**PLEASANT PRAIRIE PLAN COMMISSION MEETING  
VILLAGE HALL AUDITORIUM  
9915 39<sup>th</sup> AVENUE  
PLEASANT PRAIRIE, WISCONSIN  
6:00 P.M.  
OCTOBER 8, 2012**

**AGENDA**

SHEET NO.: C-1.0  
 CONCEPT ENGINEERING PLAN

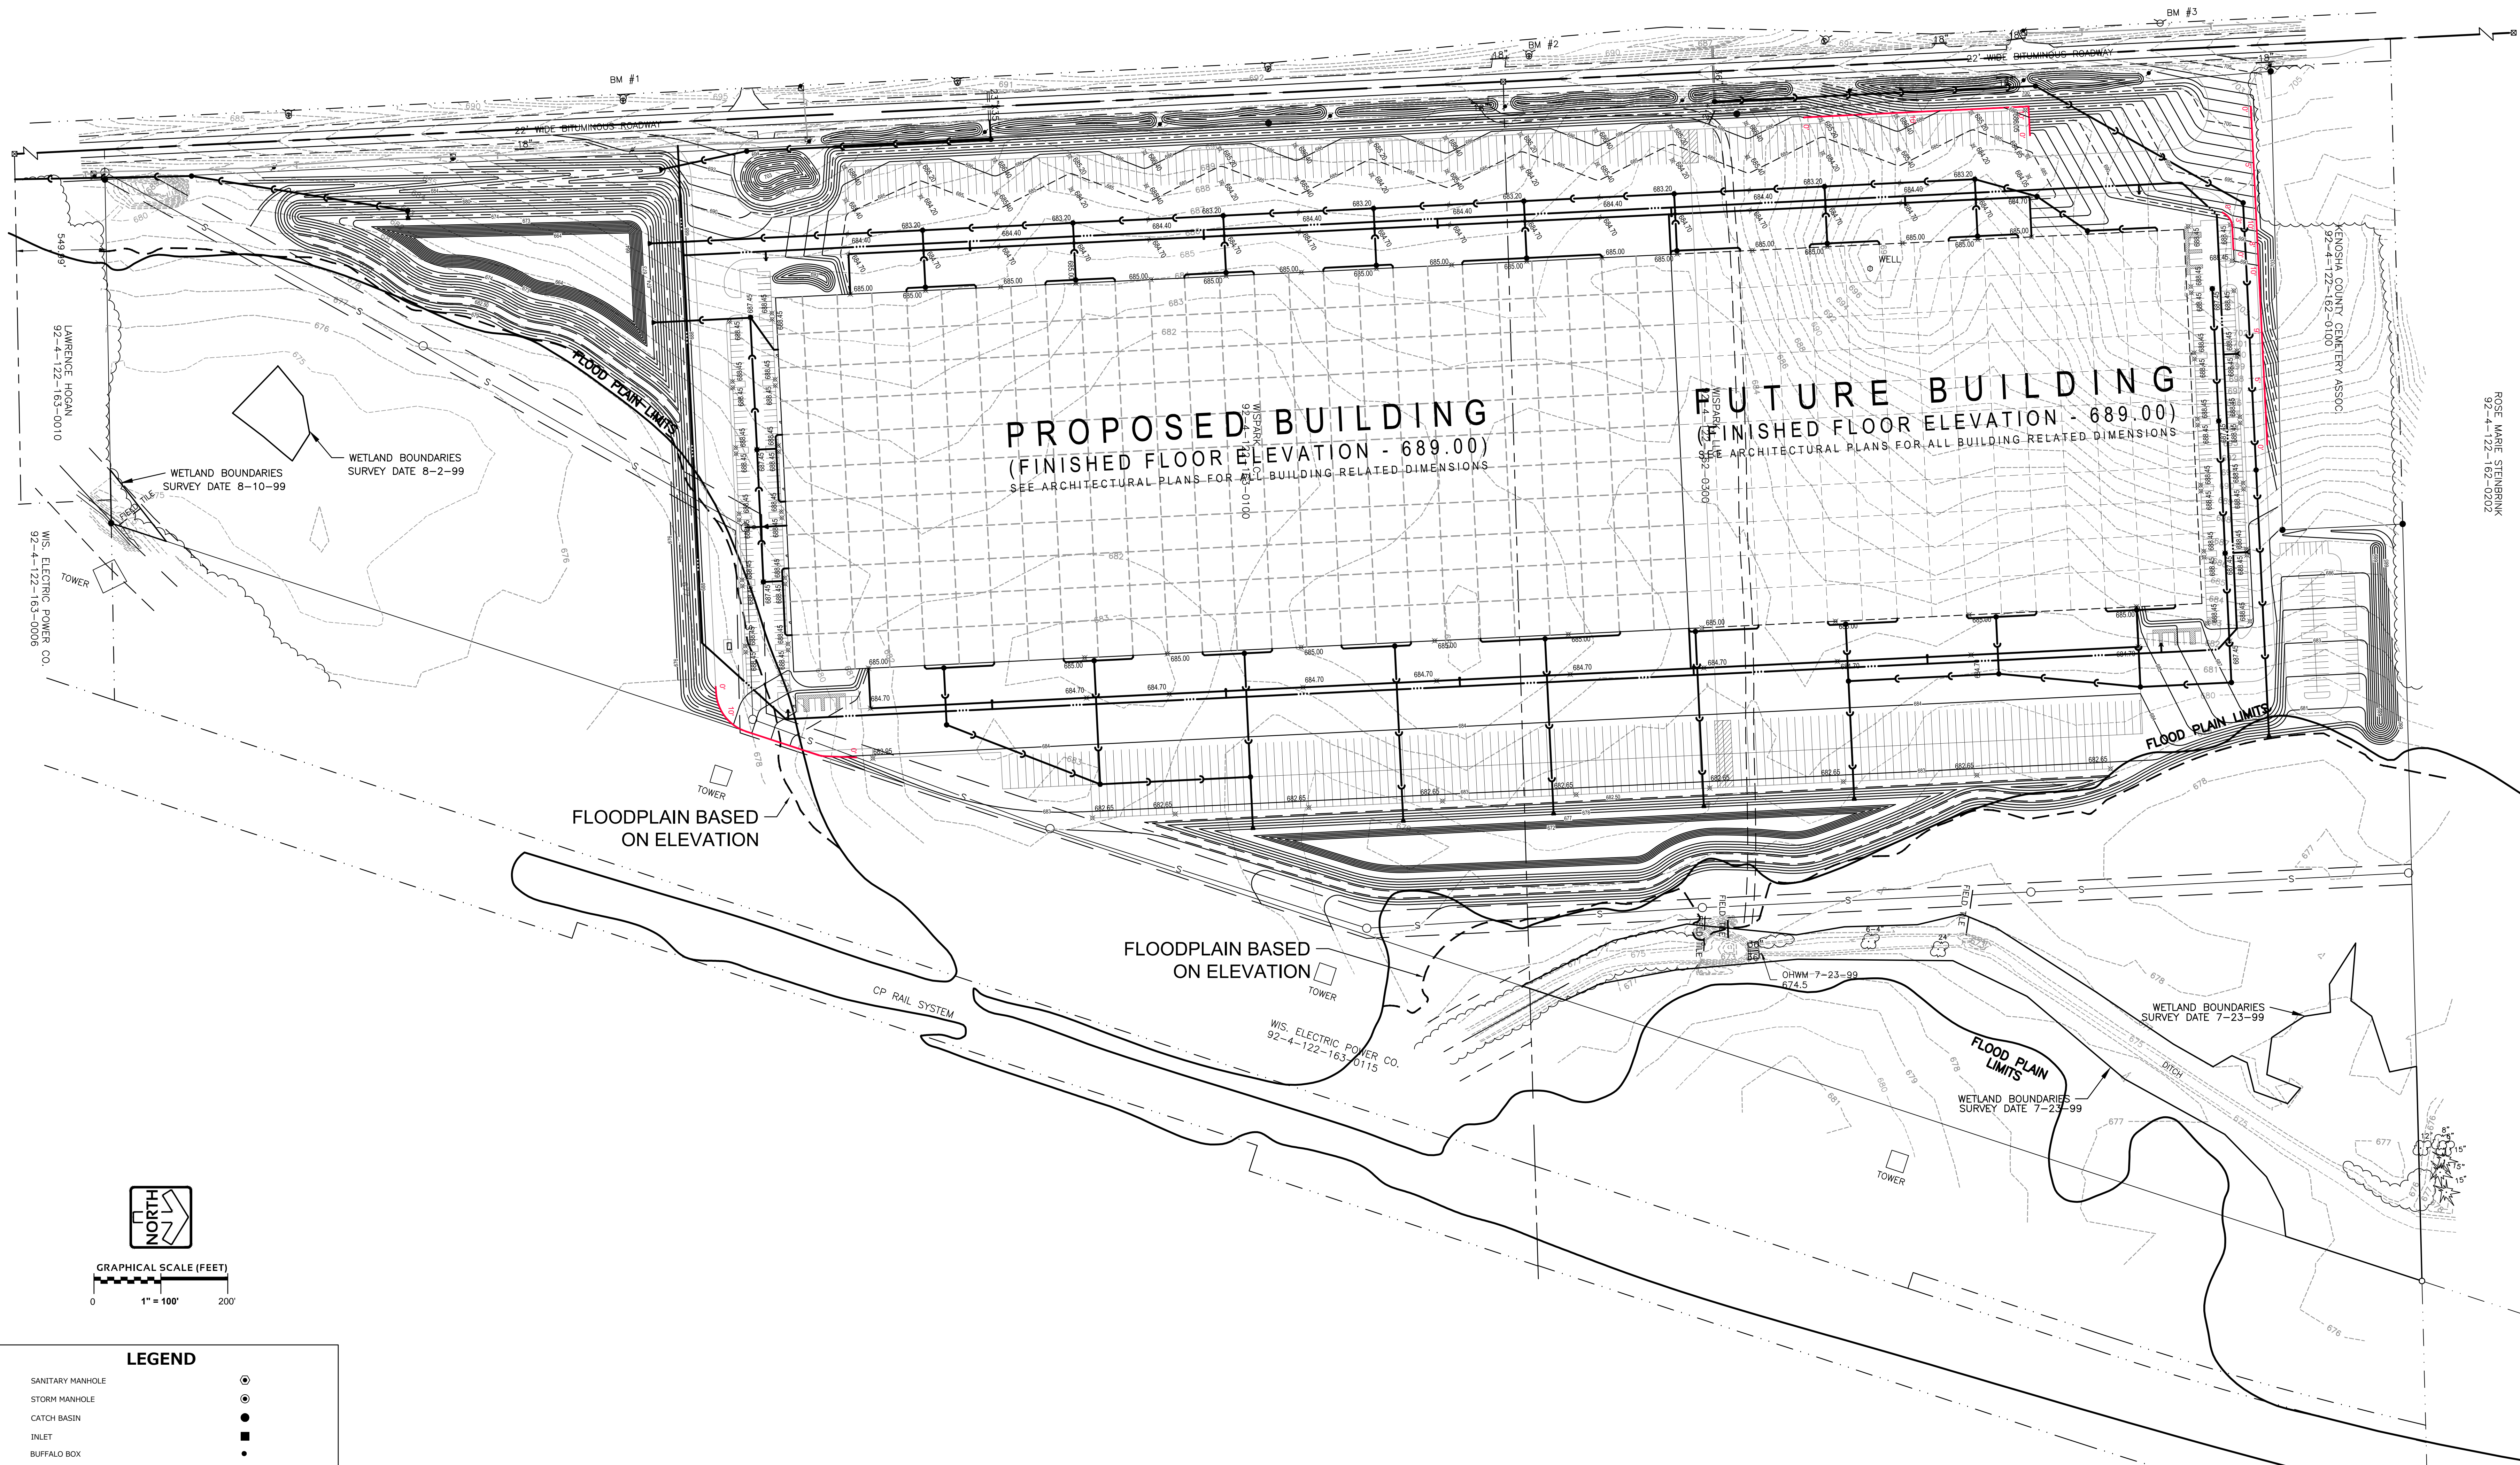
- l. On Plan Sheets A1, C-1.0 and Landscape Plan, remove the "property line" that dissects the property from east to west. This is ONE parcel of land, not two. In 2003, Tax Parcel Numbers 92-4-122-163-0100 and 92-4-122-162-0300 were combined into the current Tax Parcel Number 92-4-122-162-0301.

CCC JOB NO.	6568
SHEET NO.	A2

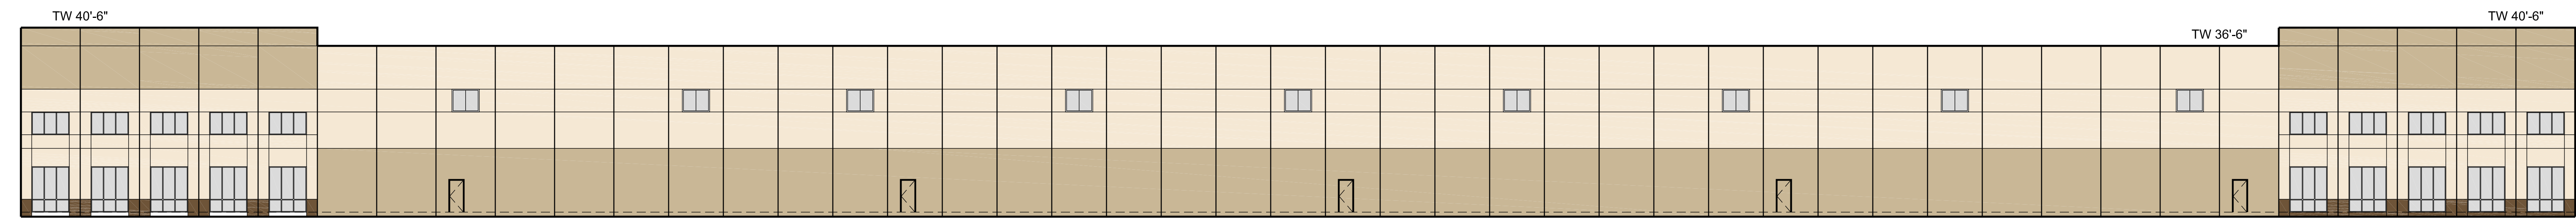
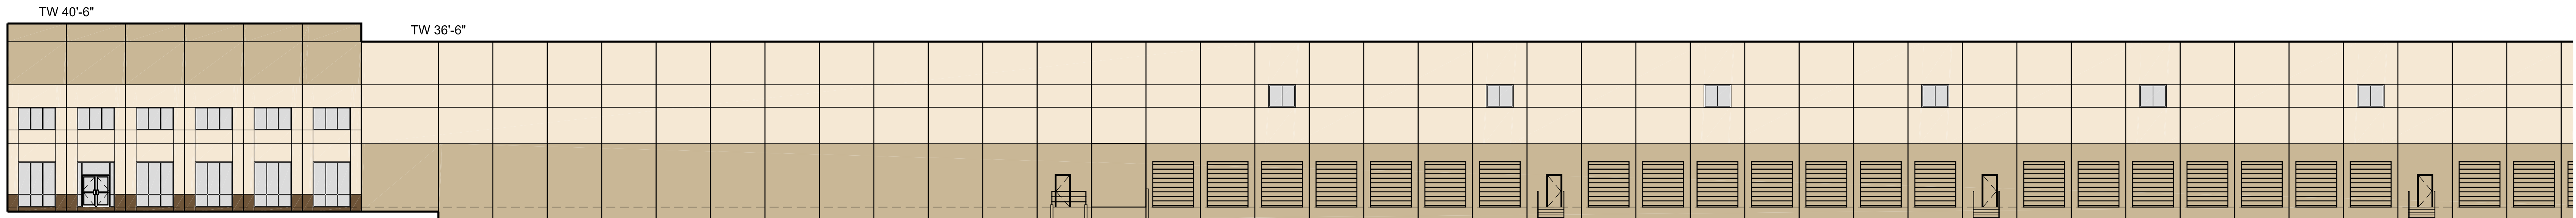
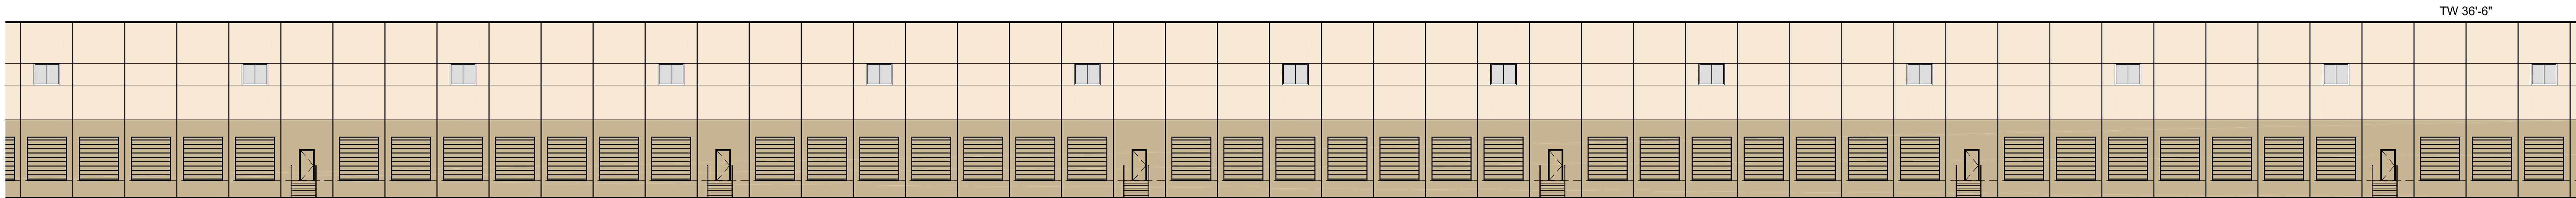
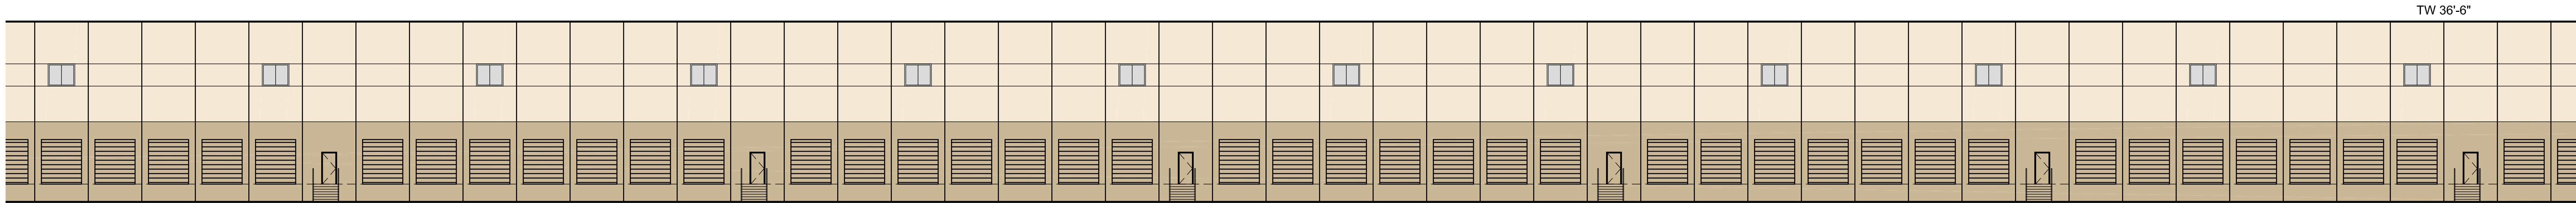
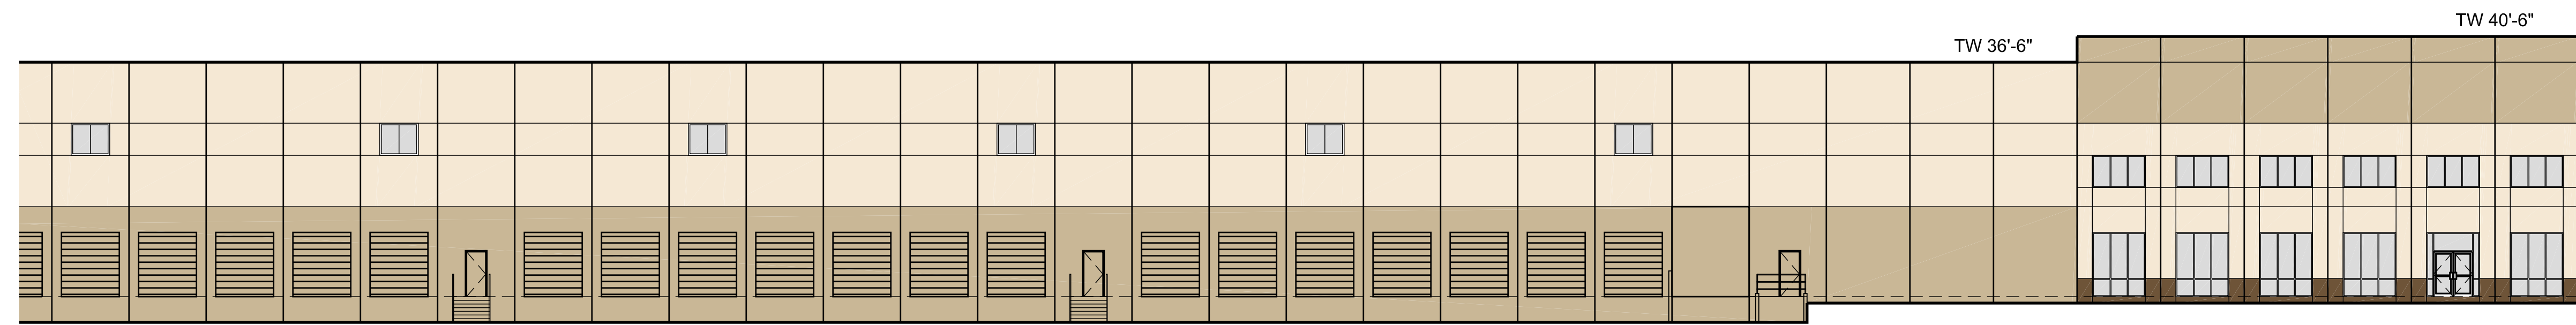
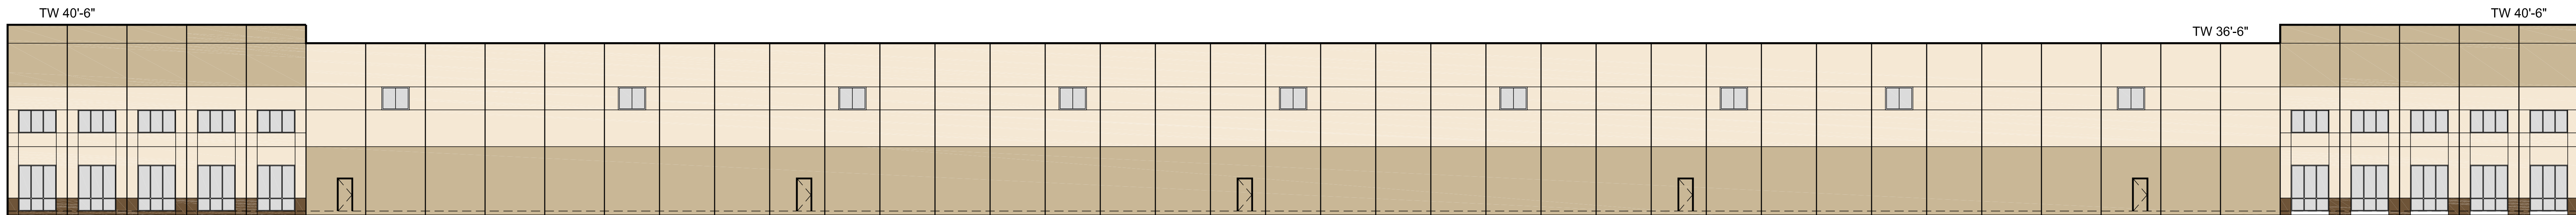
- e. On Plan Sheets A1, A2 & A3, change the notation in the title block from "Kenosha" to "Pleasant Prairie", Wisconsin.
- f. On Plan Sheet T1, include the Tax Parcel Number 91-4-122-162-0301.

SHEET TITLE  
TITLE SHEET

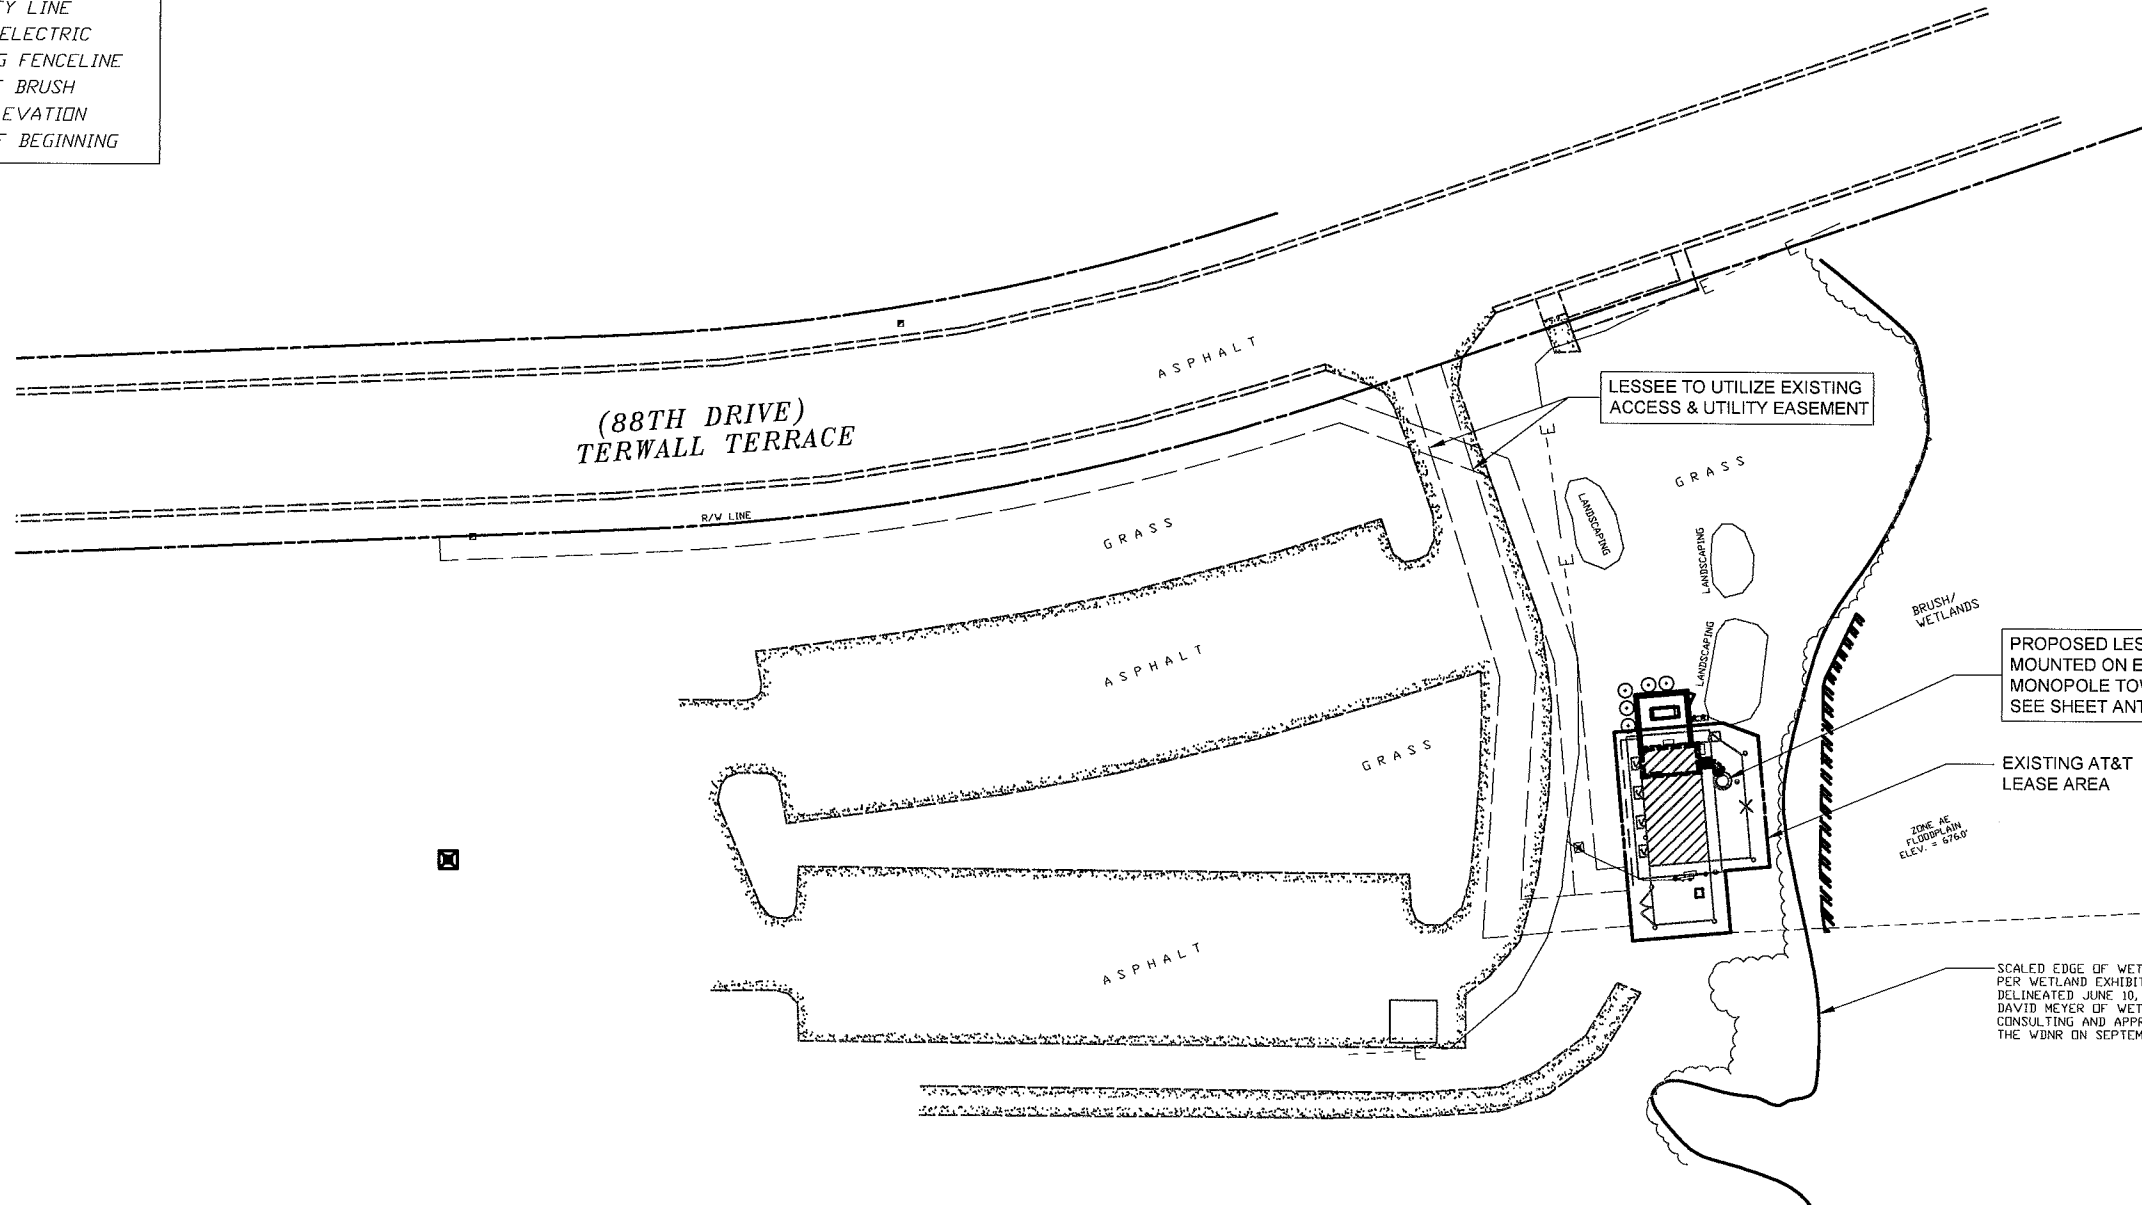
- a. The "Vicinity Map" on Plan Sheet T-1 depicts the wrong location of the cellular facility. The Site Location shall be shown correctly, south of Terwall Terrace. *Revise the plans.*

SHEET NUMBER  
**E-5**

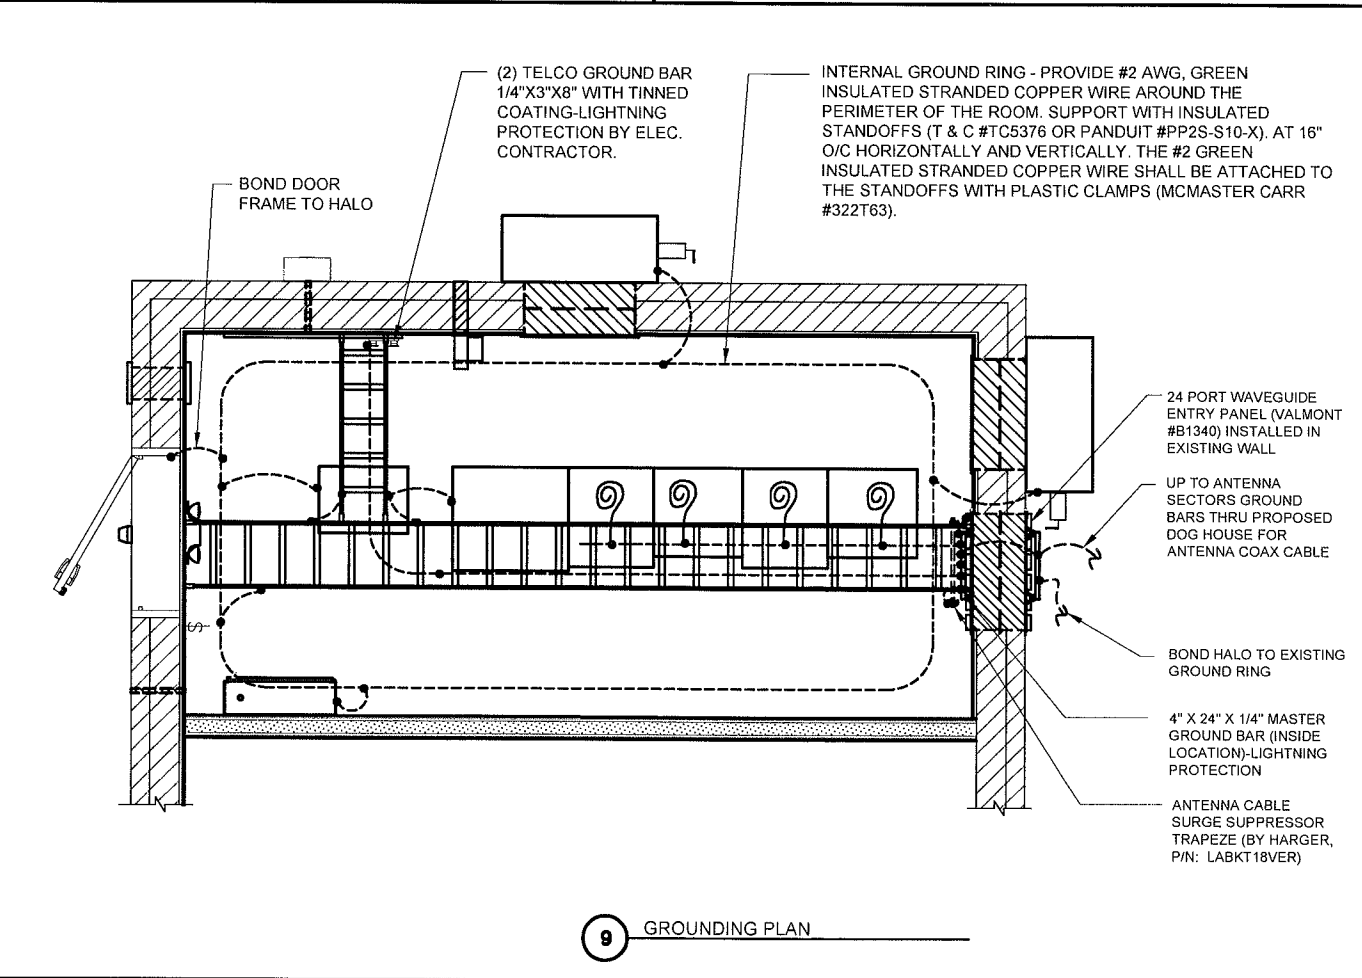
- t. On Plan Sheet E-5, the word "Clearance" is spelled incorrectly. *Revise the plans.*
  - u. To ensure that no underground cables are severed, if any trenching activities are associated with this cellular tower facility then Verizon Wireless and/or the contractor MUST contact the Village Utility Department and the Village IT Department prior to commencing any trenching/excavation/digging, etc. It may be necessary to have the Village Utility Department staff locate the Village's underground utility line(s) (sewer, water, storm sewer, fiber optic, etc.) to ensure they are not severed. *Note on the Plans.*
